Specification / Drawing Change Notice

SANYO DENKI Ref. No.: A0050472B

Product Affected: San Ace 200 9GV type
9GV2048P0G201, 9GV2048P0G203, 9GV2048P0G204,

Model No.: 9GV2048P0G205, 9GV2048P0G206, 9GV2048P0G207

Outline drawing before change (Reference)

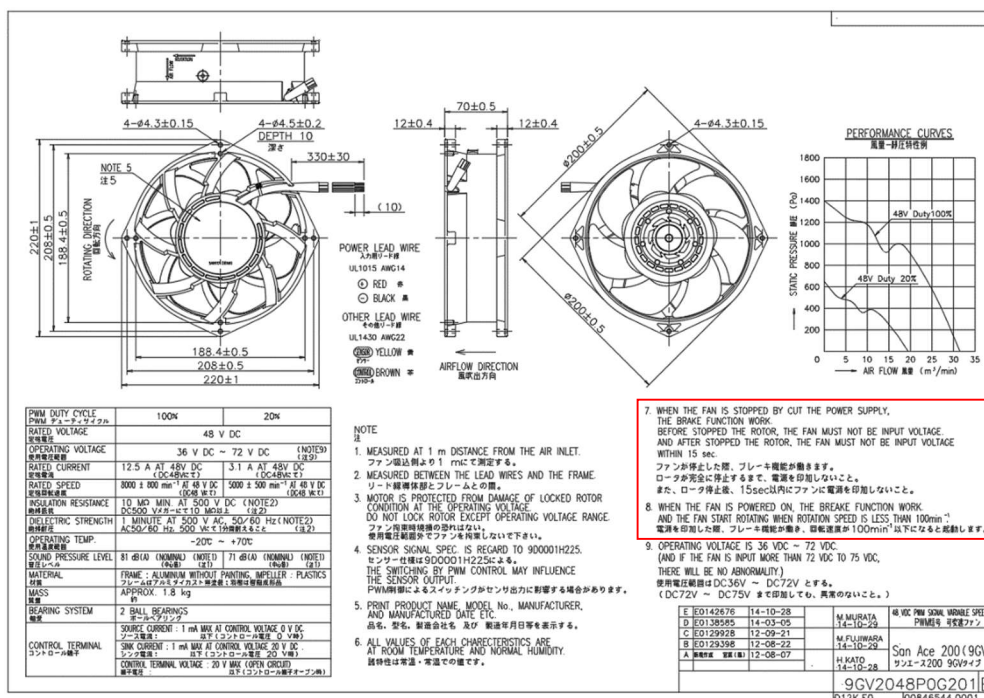
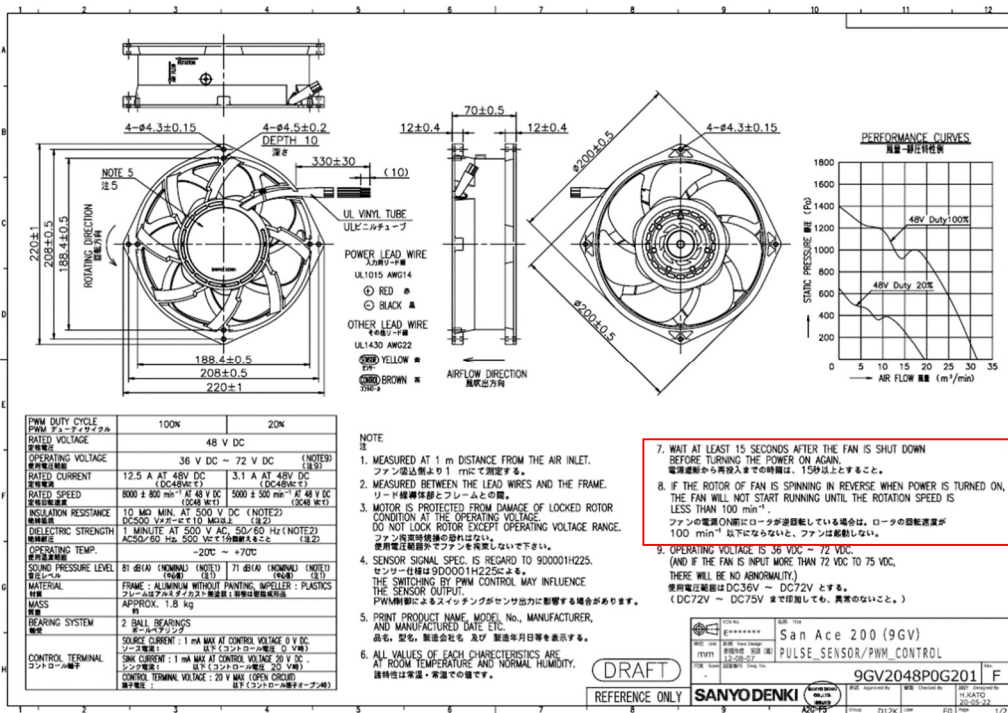
Item 3	Outline Change of the control when power is turned off
	Before Change The brake work temporarily when power is turned off.
	After Change The brake does not work when power is turned off.
	Reason for Change The control when power is turned off will be changed to match the specifications of the changed IC [PIC16F1828]. And it will be changed relevant notes of outline drawing.

Item 4	Outline Change of the control when power is turned on
	Before Change If the rotor of fan is spinning when power is turned on, the fan does not start running until the rotation speed is less than 100 min ⁻¹ .
	After Change If the rotor of fan is spinning <u>in reverse</u> when power is turned on, the fan does not start running until the rotation speed is less than 100 min ⁻¹ .
	Reason for Change The control when power is turned on will be changed to match the specifications of the changed IC [PIC16F1828]. And it will be changed relevant notes of outline drawing.
